21-061INF – FLEX-INDUSTRIAL BUILDING

Summary

Request for informal review and non-binding feedback for construction of an approximately 140,000-square-foot flex/industrial building located on a 9.34-acre site within the West Innovation District.

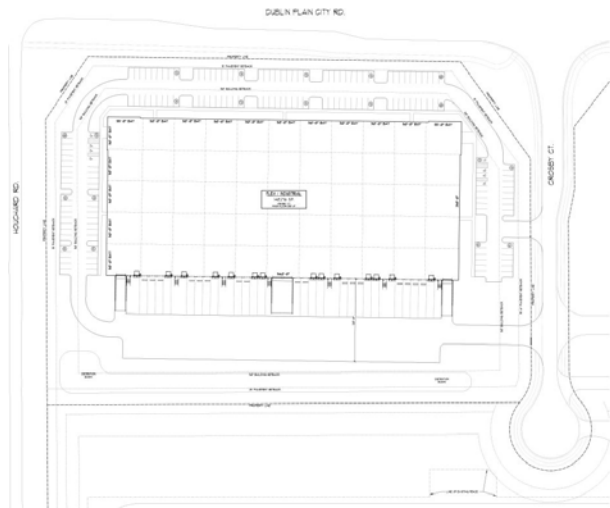
The proposed building is centrally located on the site, with two vehicular access points located along Crosby Court. The northernmost access point provides vehicular access to the employee/visitor parking lots and the southernmost access point provides vehicular access to loading docks on the south side of the building. Vehicular access to the site is only permitted along Crosby Court, as access is prohibited along Houchard Road and Dublin Plain City Road/SR 161 by the recorded plat. The applicant will be required to confirm that the proposed access points are outside the "No Vehicular Access" zone. Additionally, the applicant should align the southern access drive with the existing access drive to the east of the site.

The site plan depicts parking along the north, west, and east sides of the building, with several loading docks to the south of the building. The WID Code requires all parking, except for visitor parking, to be located along the side or rear of the structure. The site has three street frontages, with a side yard to the south of the building. The multiple street frontages create a challenge in locating parking on the site that meets zoning requirements. An Administrative Departure or Site Plan approval would be required to allow for parking forward of the structure. Parking may be able to be consolidated along fewer street frontages.

Currently, the parking provided on the north and west sides of the building do not meet the required 30-foot pavement setback. An Administrative Departure or Site Plan approval would be required to allow for a decreased pavement setback. Since the height of the proposed building has not been determined, the south building/pavement setbacks are not provided and will be required to be verified with a future application for the site.

One linear retention basin is provided along the southern property line of the site. The orientation of the pond is conceptual and will need to be modified to meet the needs of the site and to meet the requirements of the City Stormwater regulations.
